**Site Screening Process Investigation  
Work Plan for Sites 19, 26, 27,  
Wetland Area Adjacent to Site 45, and  
Stump Neck SWMUs 14 and 30**

Naval District Washington, Indian Head  
Indian Head, Maryland

Contract No N62470-02-D-3052  
CTO-0050

**FIGURE 5-1**  
**SITE 19 PROPOSED SAMPLE**  
**LOCATIONS AT BUILDING 785**  
 SSP INVESTIGATION WORK PLAN, CTO-050  
 NDWIH, INDIAN HEAD, MARYLAND

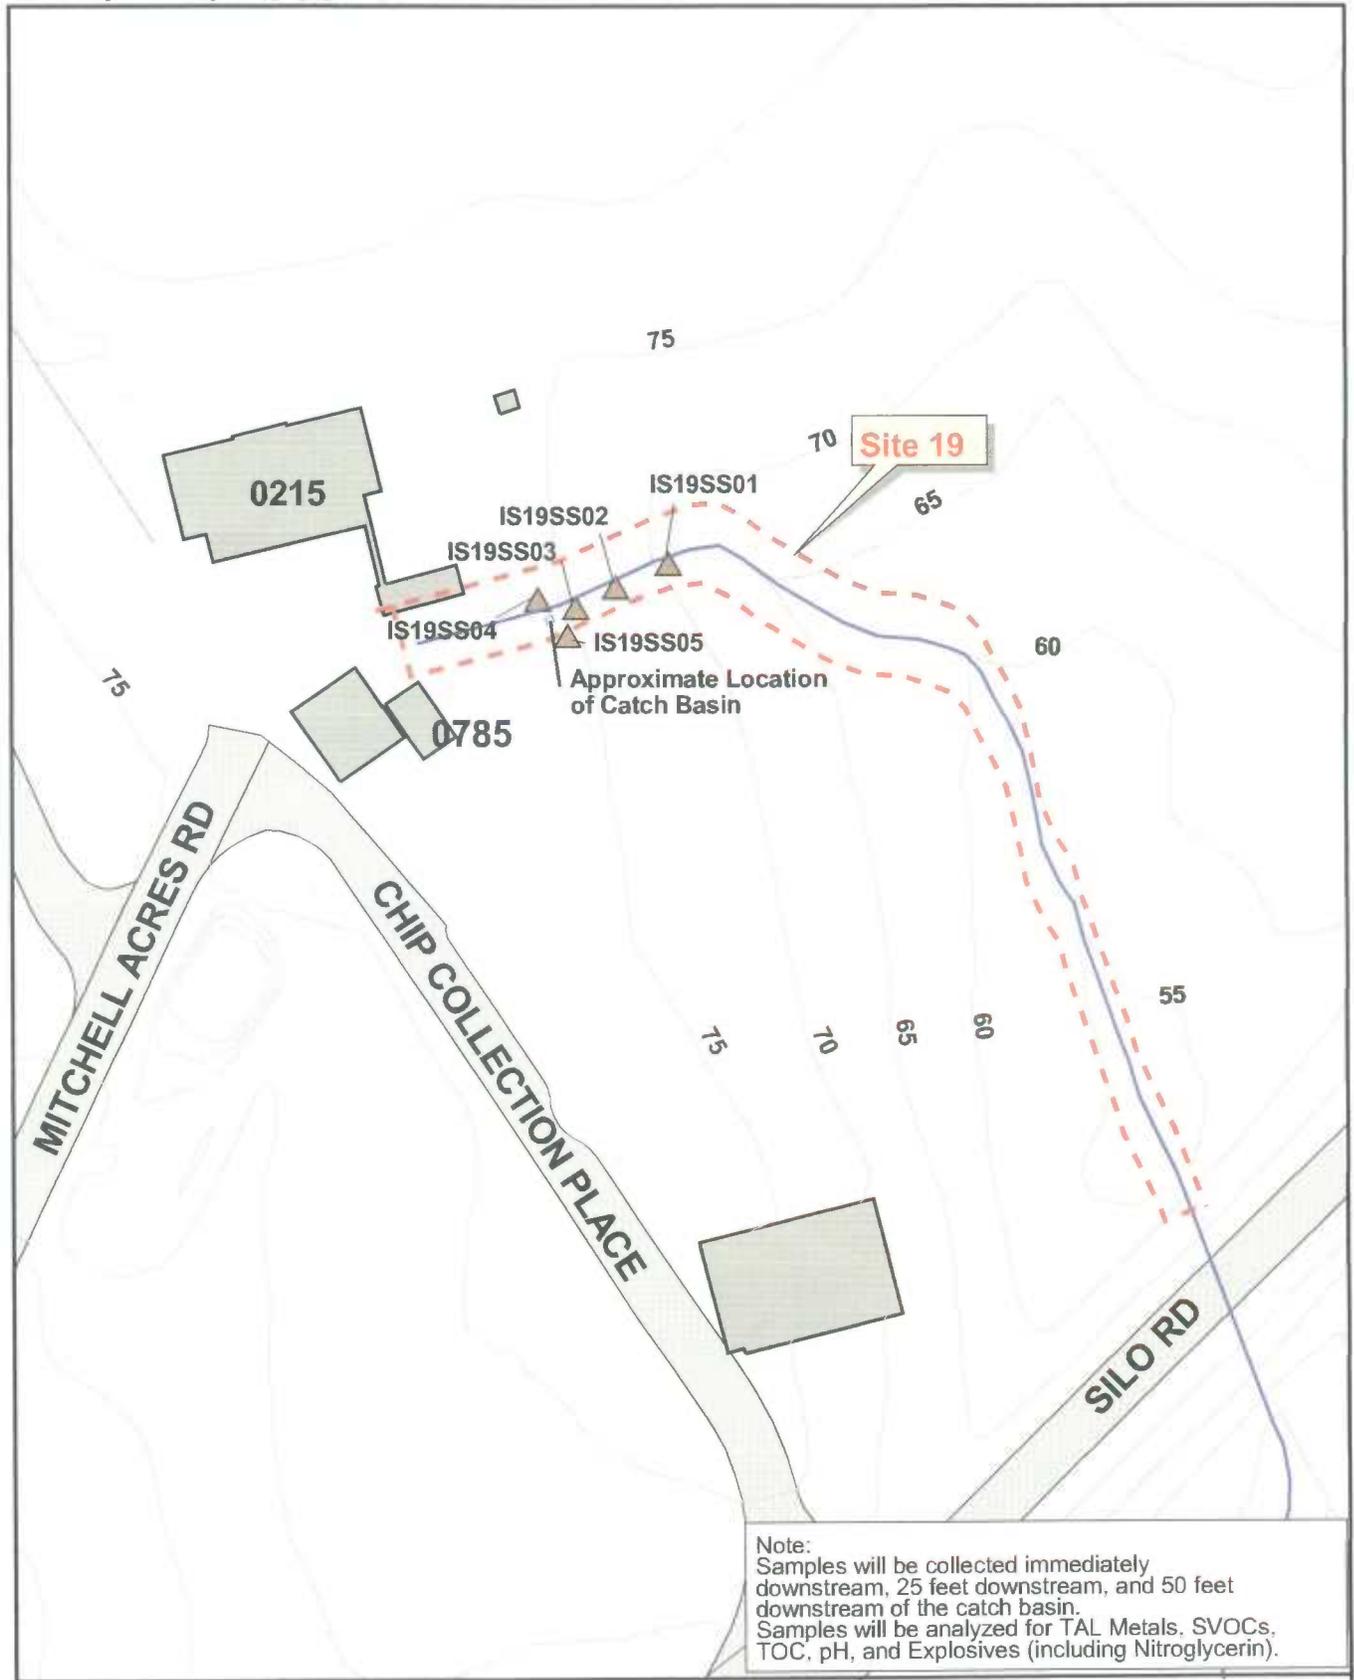
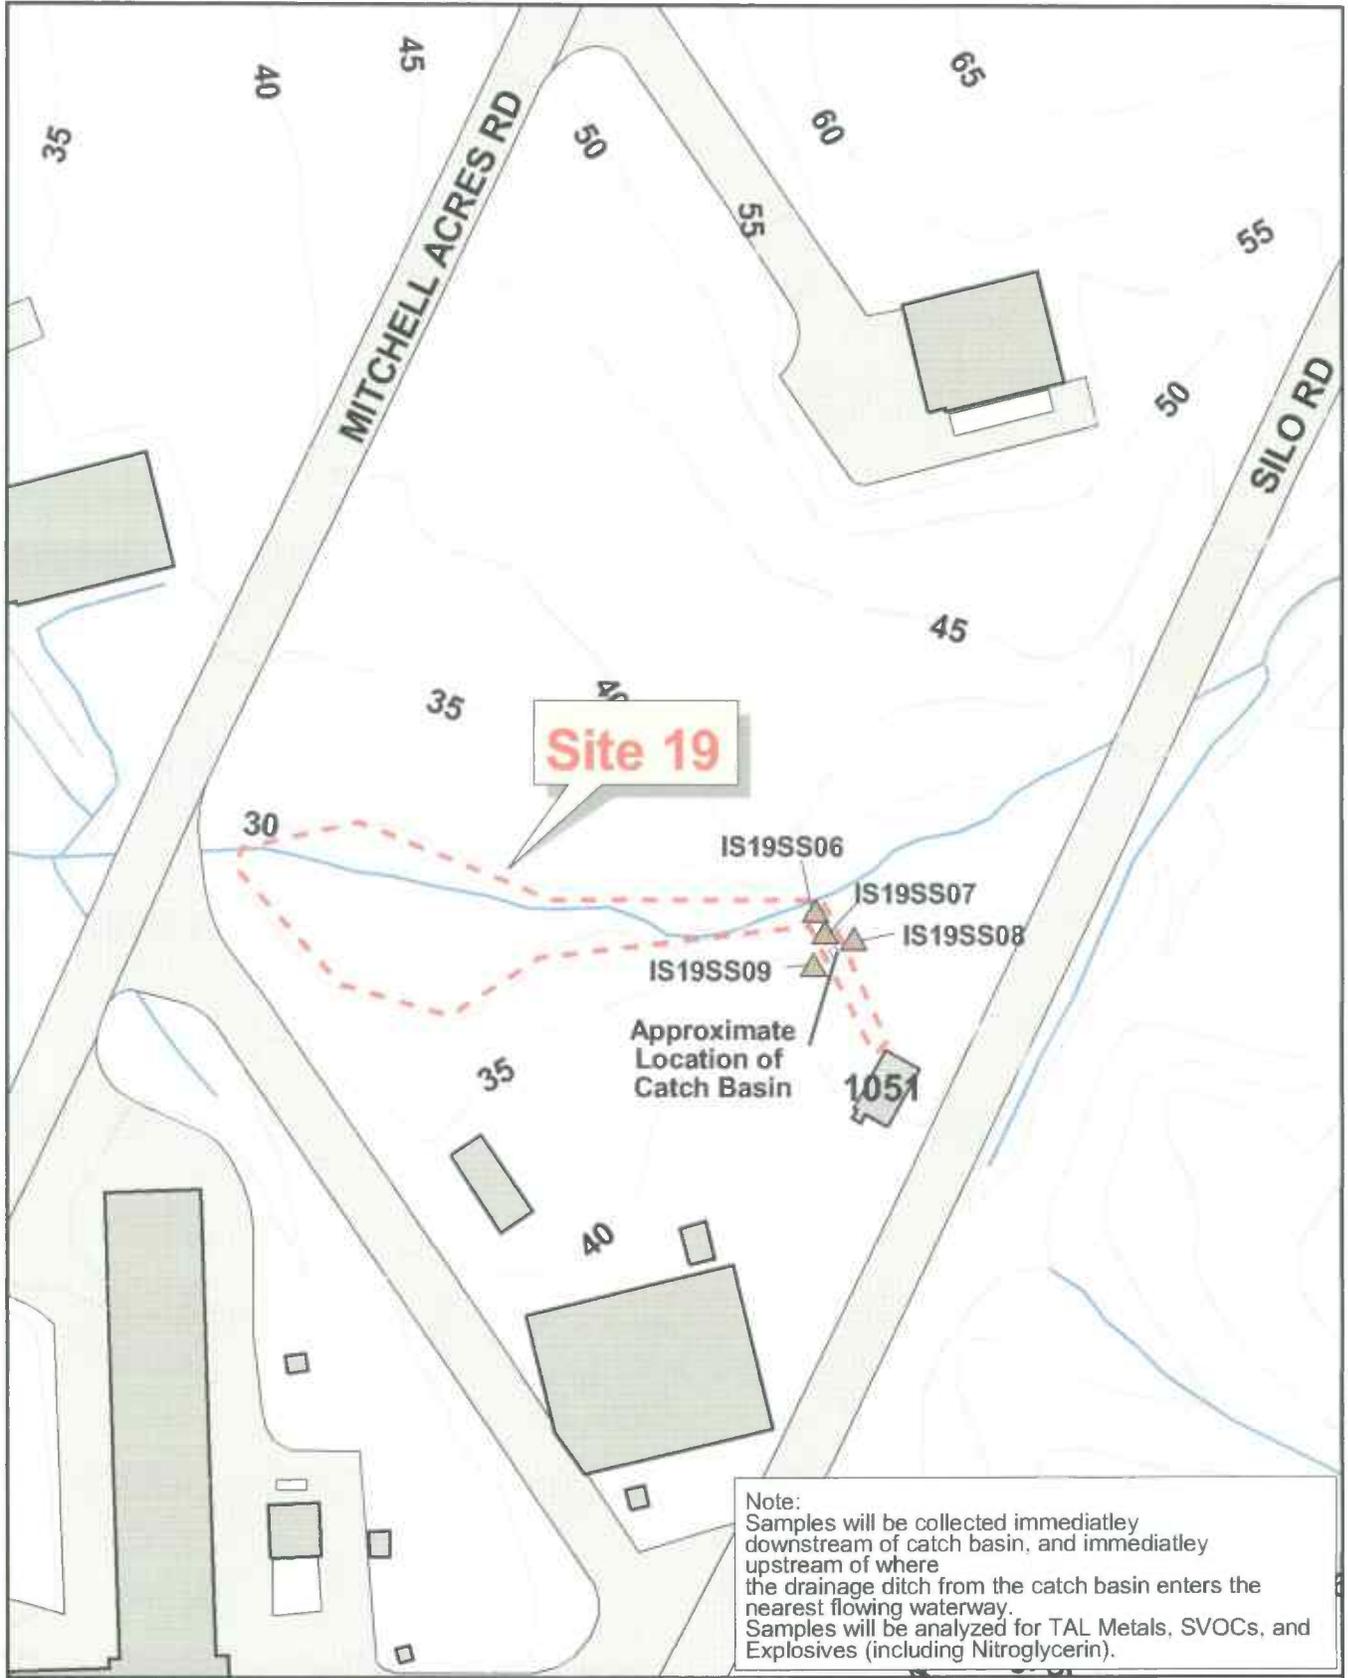
*Given that lead and copper salts are relatively soluble, limiting sampling in the drainages to within 50 feet of the catch basins may not be adequate for detecting the more soluble COPCs. Also, some explosives are slightly water-soluble (e.g. nitroguanidine and nitroglycerin) and may impact ground water. Can ground water truly be written off at this point as not impacted? (Also affects Figures 5-1 and 5-2) SEE ABOVE COMMENT REGARDING POTENTIAL EXPLOSIVE HAZARDS.*

It appears that all of the samples will be collected within 50 feet of the discharge point. Figure 5.1 indicates a rather steep slope of 5 feet every 50 feet. This could suggest contaminants were transported further down gradient. It's unclear how steep the gradient is from the Bldg 1051 catch basin.

5.3	5-2, also Figures 5-1 and 5-2	Given that lead and copper salts are relatively soluble, limiting sampling in the drainages to within 50 feet of the catch basins may not be adequate for detecting the more soluble COPCs. Also, some explosives are slightly water soluble (e.g. nitroguanidine and nitroglycerin) and may impact ground water. Can ground water be written off at this point as not impacted? SEE ABOVE COMMENT REGARDING POTENTIAL EXPLOSIVE HAZARDS.
5-4 and 5-5	Figures 5.1 and 5.2	It appears that all of the samples shall be collected within 50 feet of the discharge point. Figure 5.1 appears to drain rapidly 5 feet every 50 feet. Would this change to likelihood of being moved further down gradient? Unclear how rapid the gradient is from Bldg 1051 catch basin.
6-2	6.3	Since hydrazine and UDMH are both largely miscible in water. Can one write off the ground water pathway due to rapid oxidation of these compounds? If this is possible, then the factual case needs to be made for this assumption.
